CLE	881 3 983 001	1/1	27/03/00
	2017A	881 3 983 001	C

002	1	PIED Ø3-10	STUB		
001	1	CLE	2017A	OXYD. ANOD. NOIR	
PL	REP	QUANT	DESIGNATION	MATIERE	OBS
		DESSIN PAR: SETA VERIFIE PAR: PROUM DATE: 11/10/99	INTERPRETATION DES DESSINS SELON: ST 2100 DATE:		
		MACHINE/ENGINE: REGULATEUR	PIECES / PART NUMBER Ø 316 Ø 731 Ø DATE:		
		DESIGNATION OUTILLAGE: CLE DE MANOEUVRE	DATE:		
		TOX. AMME	DATE:		
			DATE:		
			DATE:		
<p>CE DESSIN EST LA PROPRIETE DE LA SOCIETE TURBOMECA, IL NE PEUT ETRE COMMUNIQUE, OU REPRODUIT SANS SON AUTORISATION THIS DRAWING IS THE PROPERTY OF TA AND MAY NOT BE COPIED OR COMMUNICATED WITHOUT EXPRESS AUTHORIZATION</p>					
		ECHELLE SCALE 1/1	 CODE FABRICANT 10228 / MANUFACTURER CODE		
		FORMAT A1	PLANCHES SHEET 1/1 DATE 22/10/99 / REPS DATE 27/03/00

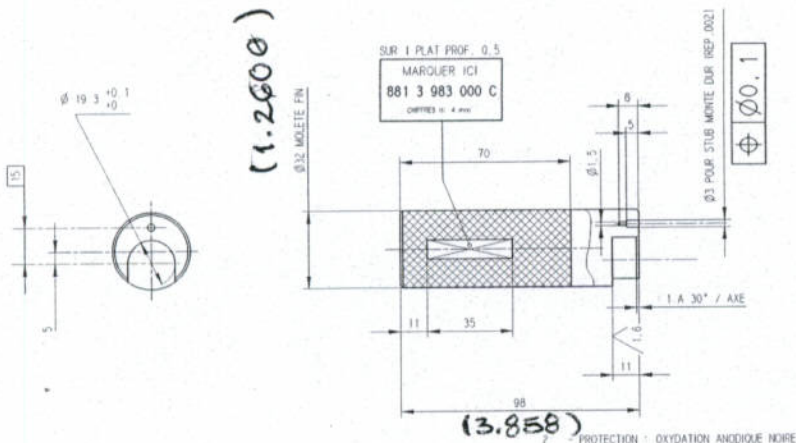
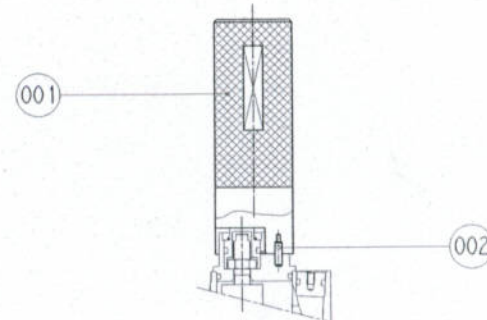
MODIFICATIONS		REVISION
COTE 100 DEVIENT 98	A	
OUVERTURE DU Ø19.3 ±0.1	B	
Ø317 → Ø31 POUR STUB MONTE DUR	C

MODIFICATIONS		REVISION
MODIFIE LE REP. 001	A	
MODIFIE LE REP. 001	B	
MODIFIE LE REP. 001 - SUPPRIME PENTRATAGE SUR REP. 002	C
